# City of Coconut Creek

## InterOffice Memorandum

Subject: The Promenade at Coconut Creek  
Modification to Site Plan

Drawing No. **C-2**

Drawing Title: **SITE PLAN**

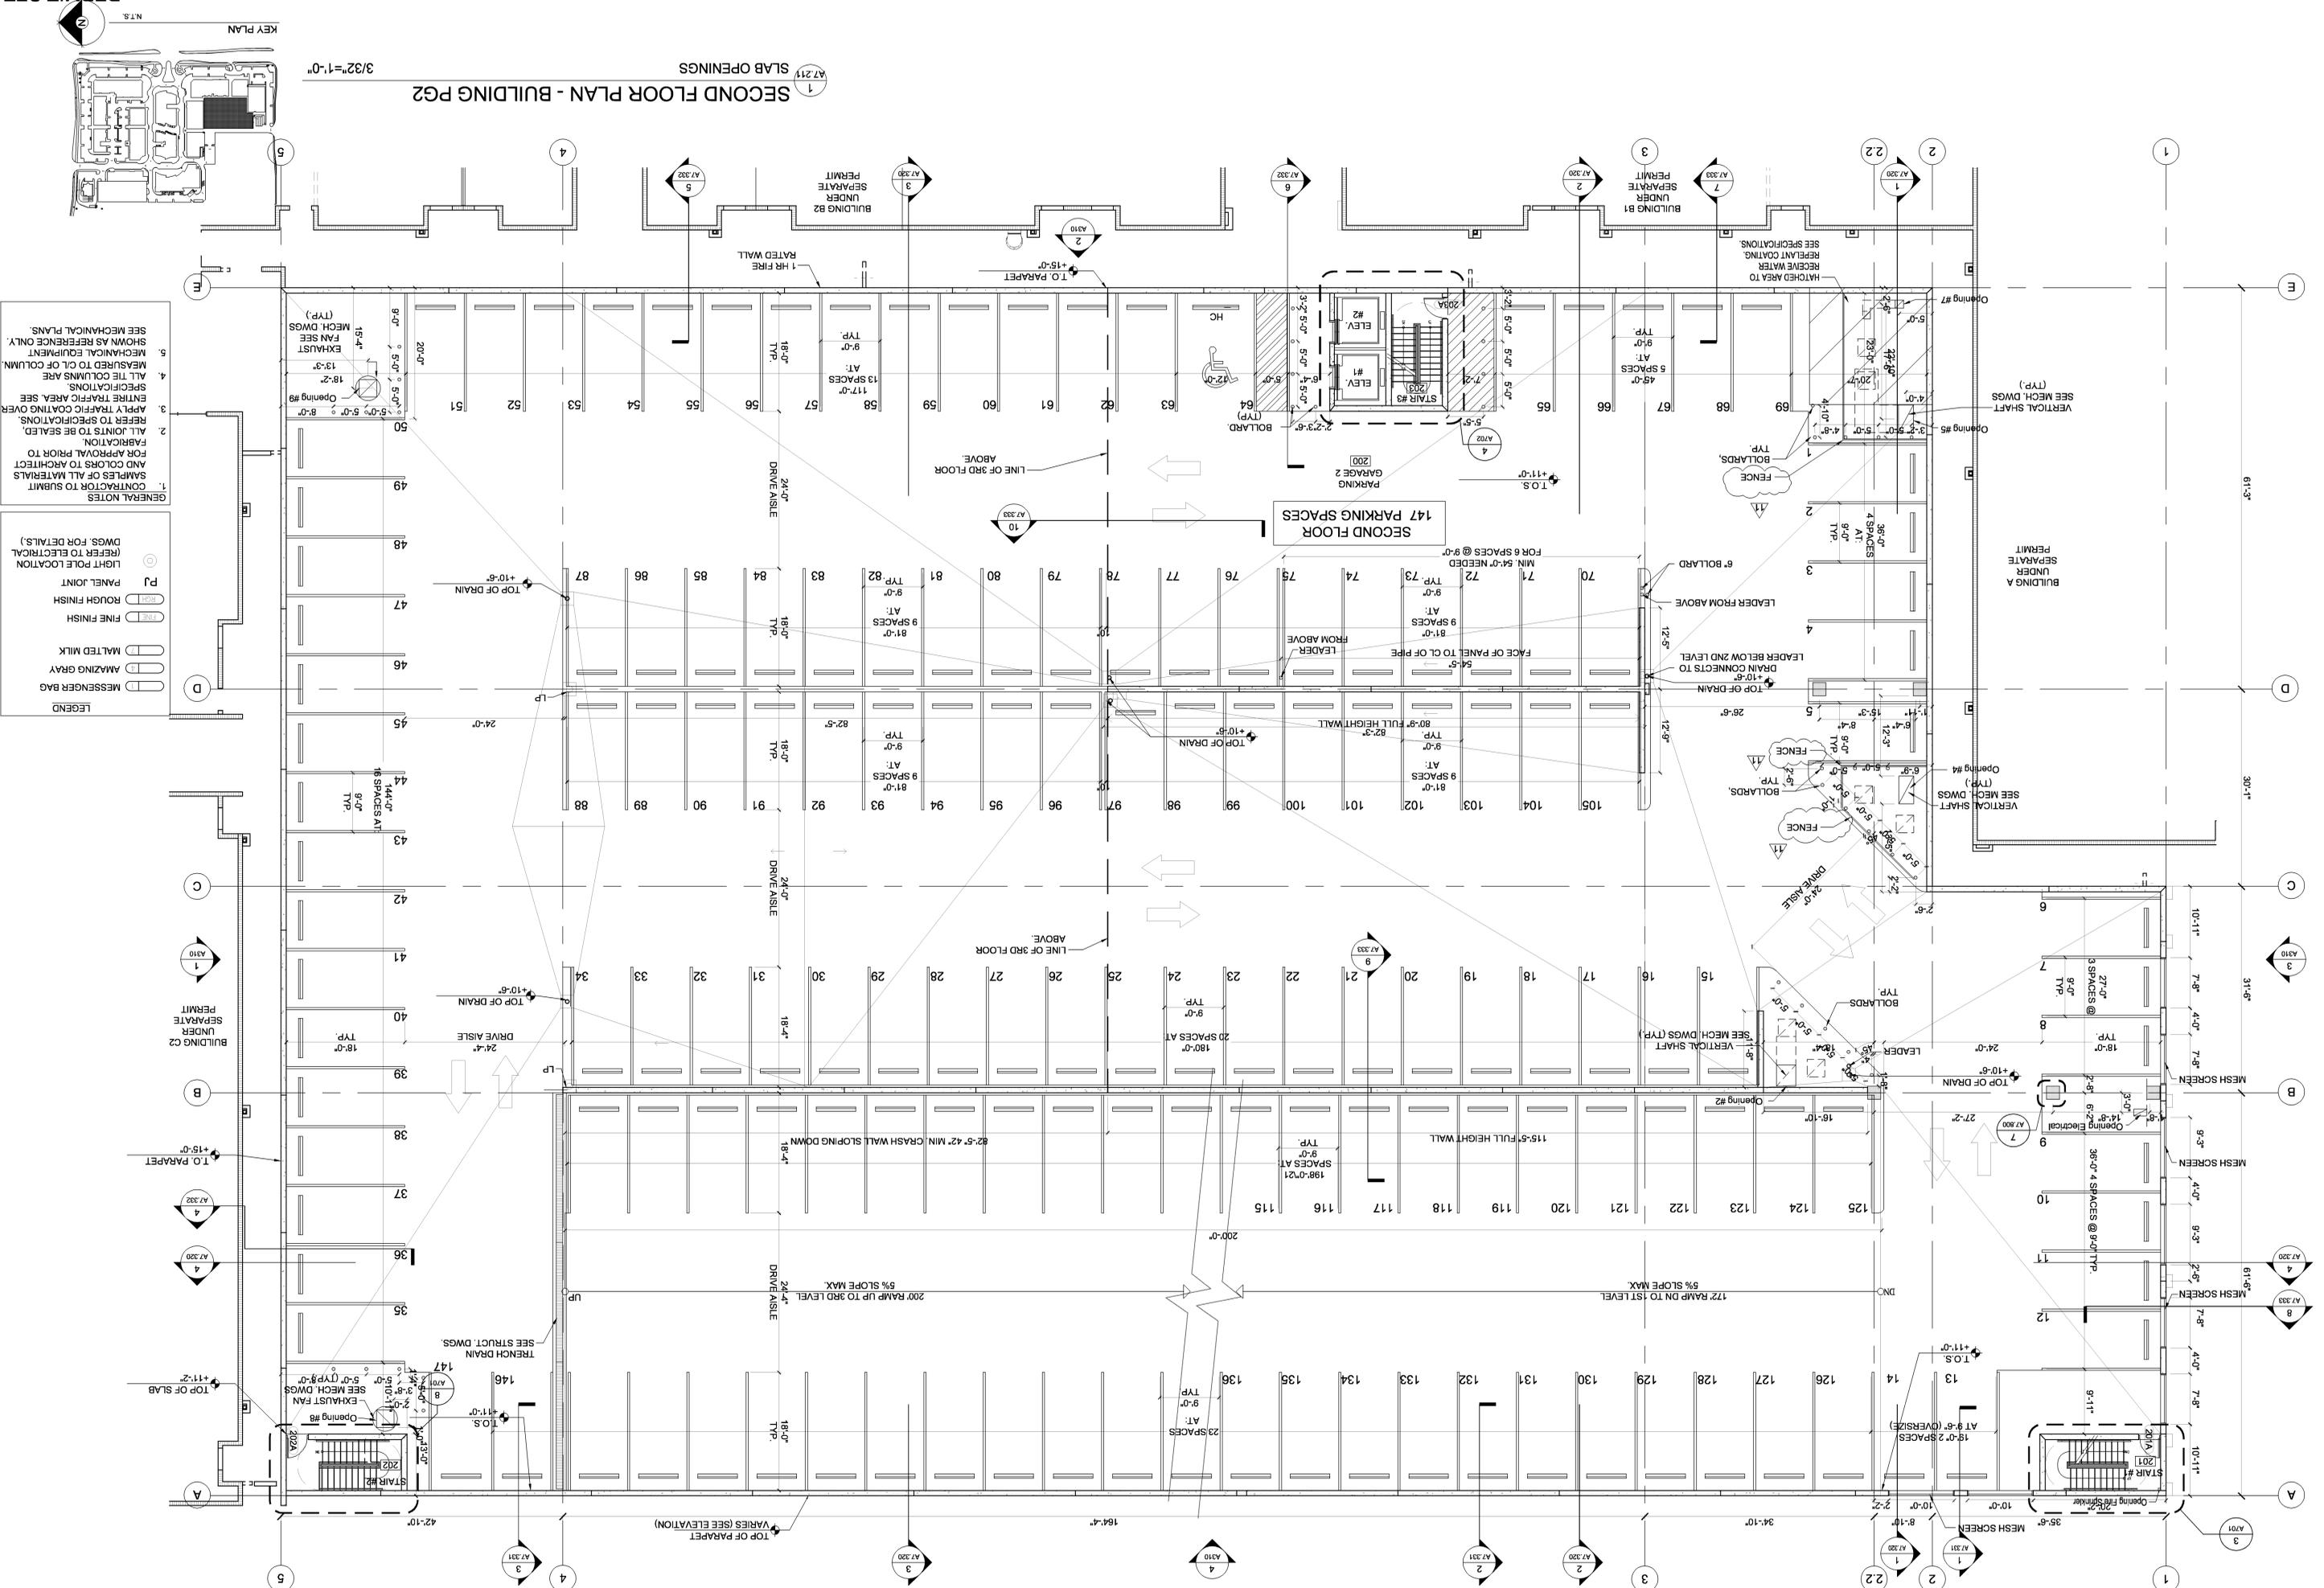
Date	Description	No.
11/10/08	ADDED STORAGE NEAR NW OF BLDG. G1, SW OF BLDG. E, SE OF BLDG. H2 AND AT THE LYONS ROAD MAIN ENTRANCE	28
10/29/08	REVISED PARKING SPACE COUNT FOR BLDG. PG-2 PER COORDINATION WITH ARCHITECT	25
09/15/08	REVISED FOR ADMINISTRATIVE APPROVAL COMMENTS DATED AUGUST 28, 2008	24
07/18/08	REVISED FOR MASTER SITE BUILDING PLAN	23
06/19/08	REVISED PARKING TABLE	22
04/14/08	REVISED PER ADMINISTRATIVE APPROVAL COMMENTS DATED APRIL 1, 2008	21
03/07/08	REVISED FOR ADMINISTRATIVE APPROVAL SUBMISSION	20
02/12/08	REVISED FOR BUILDING PERMIT	19

1 SECOND FLOOR PLAN - BUILDING PG2  
3/32"=1'-0"

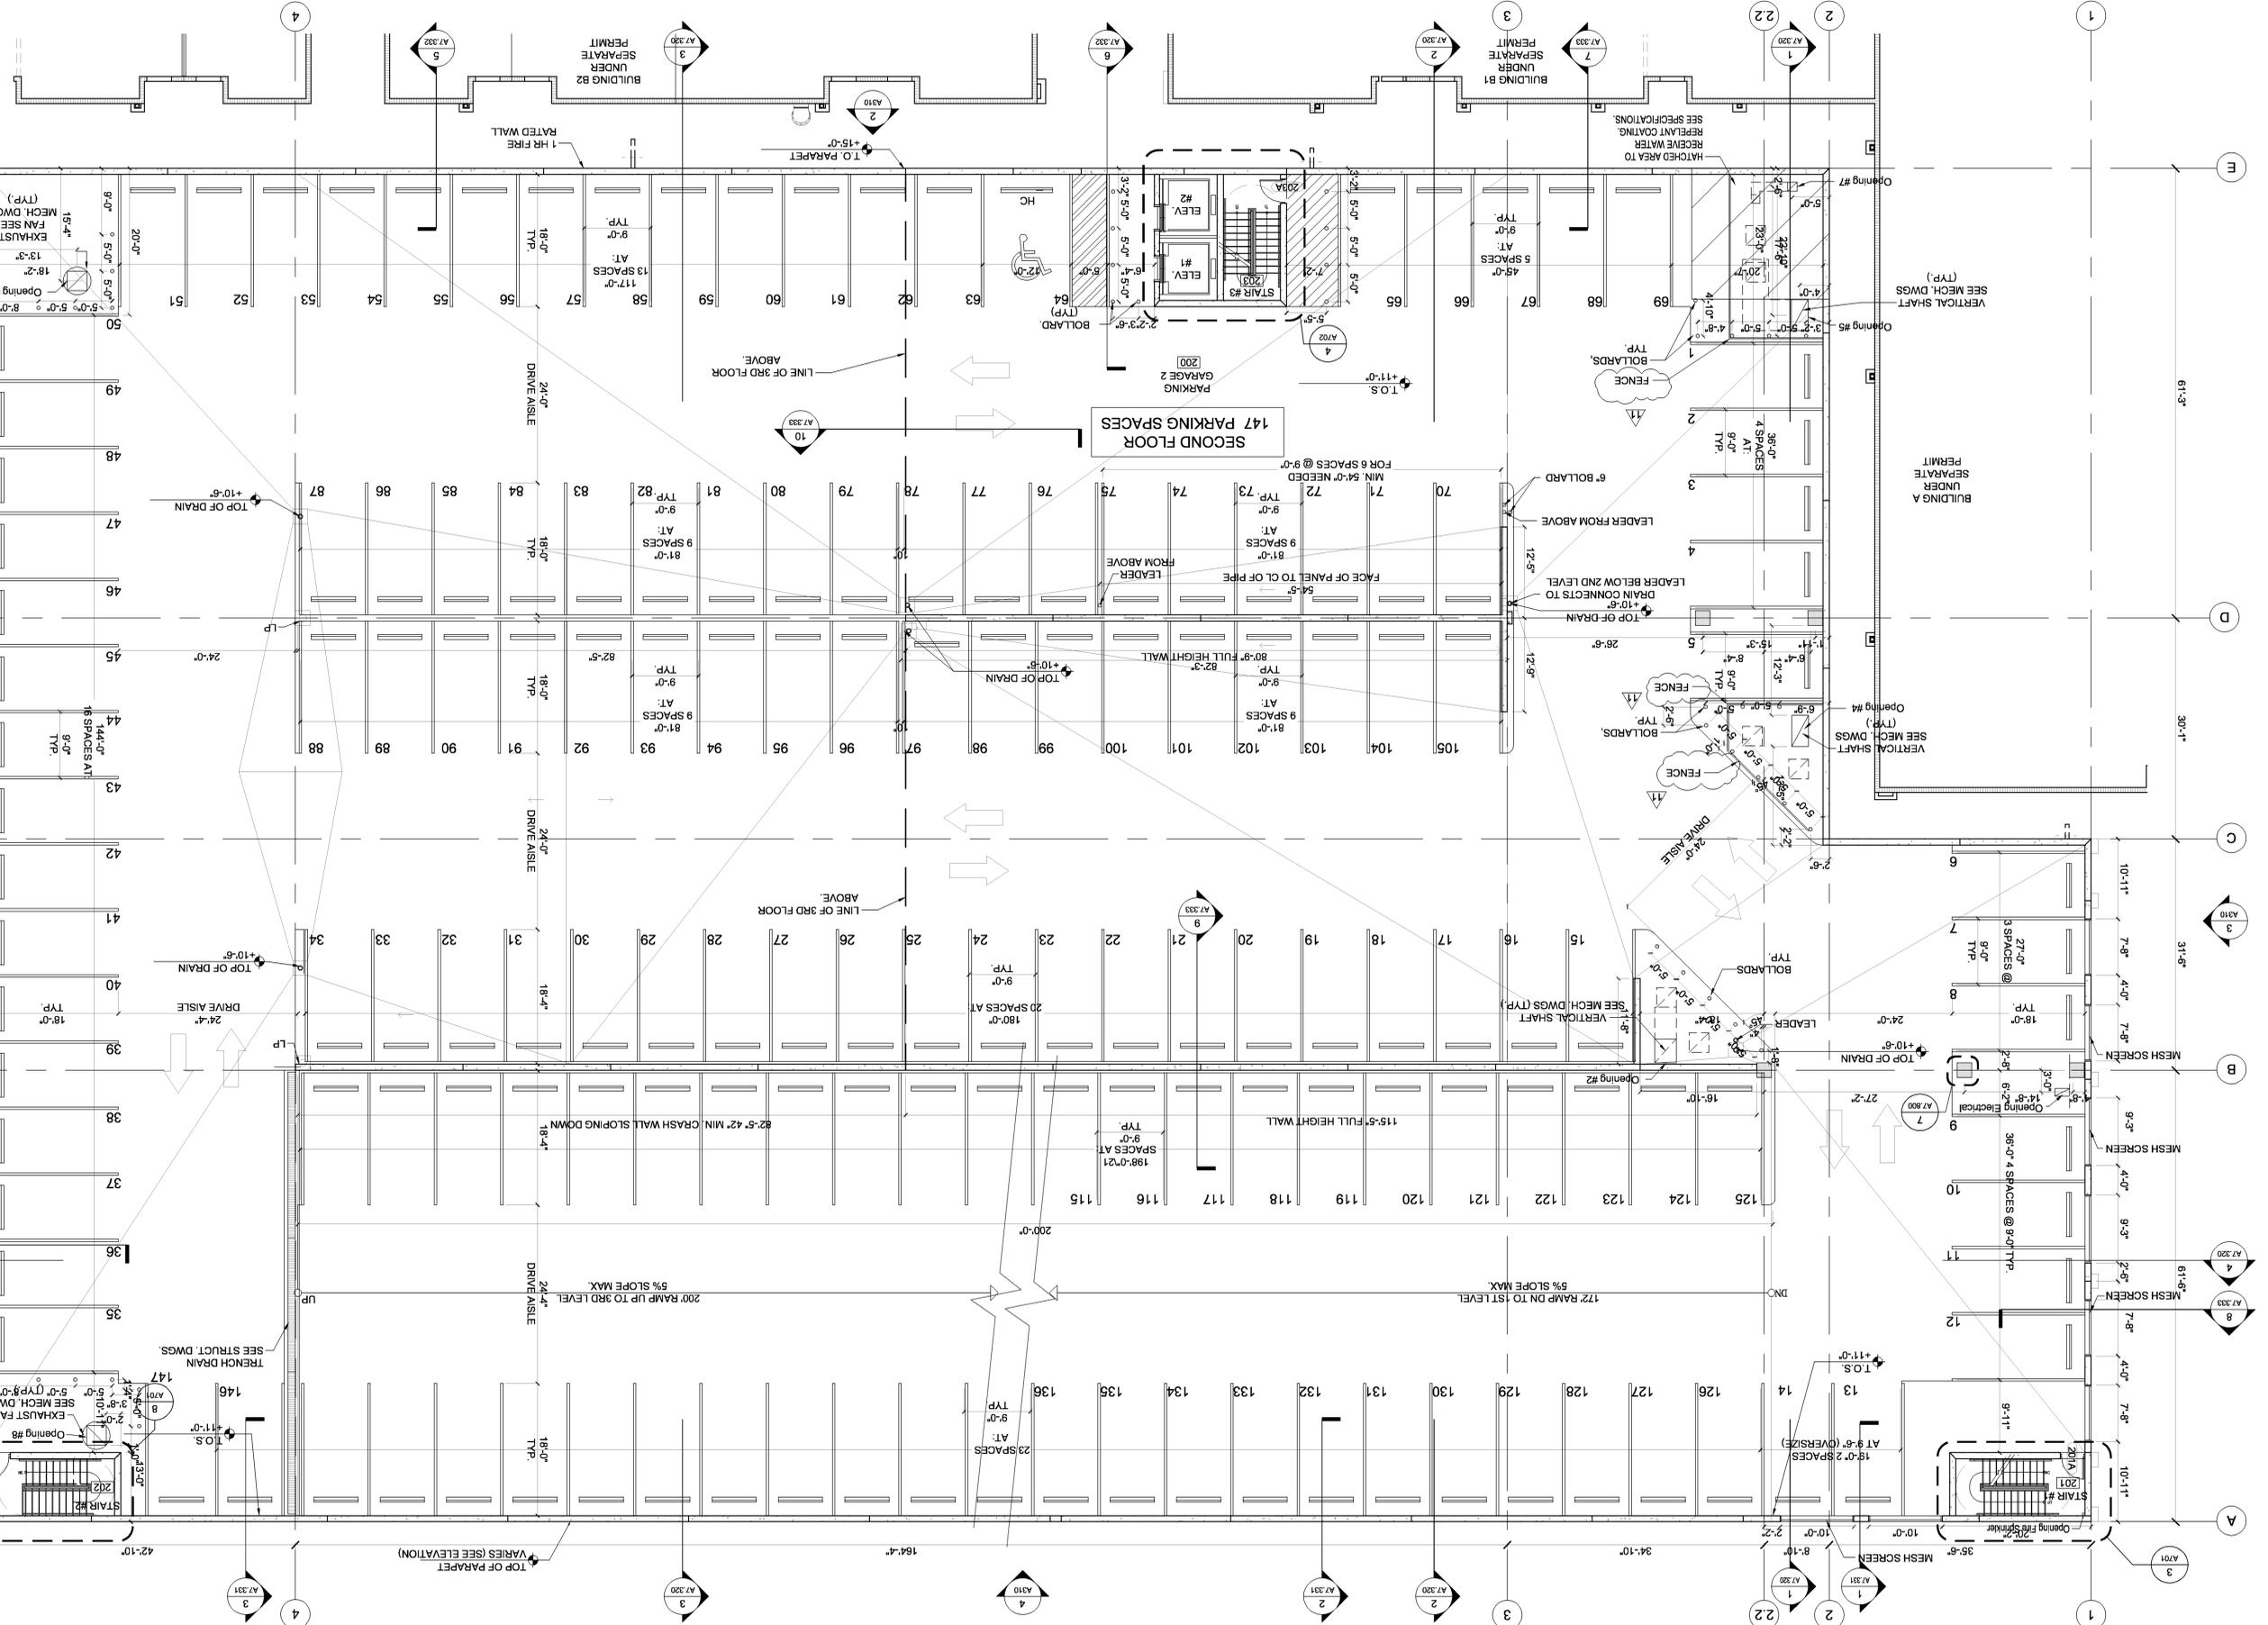
- Elimination of 2 surplus parking spaces in Parking Garage 2
- Installation of fence in Parking Garage 2 for clearance issues

The applicant is requesting to eliminate 2 parking spaces in Parking Garage 2. The spaces conflict with conduits and electric panels which were not depicted on the approved site plan. The elimination is to address safety clearance along with the installation of fencing for protection. There is a surplus of parking spaces for the site and therefore, the elimination of the spaces should not be an issue.
